SERVICE BULLETIN
FAA/DAS APPROVED

NUMBER CSB-2002-01
DATE 1-21-02

SUBJECT: Intermittent Roll and Pitch Deviation

The following drawing depicts the modification to be made to the Century 2000 Basic Autopilot Circuit Board part number 81D664- () (28 volt aircraft) or 81D665- () (14 volt aircraft). This board is the bottom most circuit board.

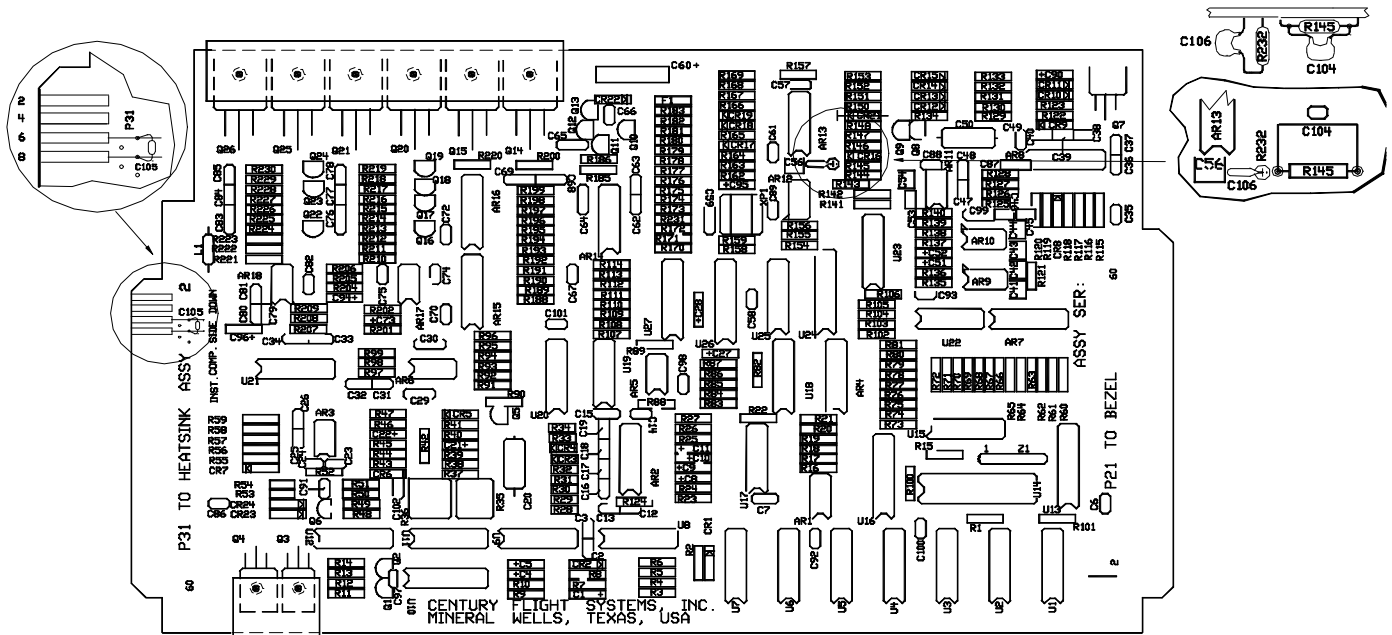
1. Install a .1mf capacitor (C105) across pins 6 & 8 of edge connector P31. Use existing feed through holes at connector to secure capacitor.
2. Remove C55 from circuit board. Take a 1.5K (R232) resistor and connect one lead to one end of a .047mf capacitor (C106). Form resistor and capacitor as shown above. Connect other lead of R232 & C106 and connect to holes where C55 was located. Insure the lead of C106 is closest to body of C56 and no taller than local components.
3. Install a .01mf capacitor (C104) across resistor R145.
4. Install supplied placard to top cover at the front of the flight computer. If performing the requirements of this Service Bulletin from the Internet, make a placard from an address label with the following information:
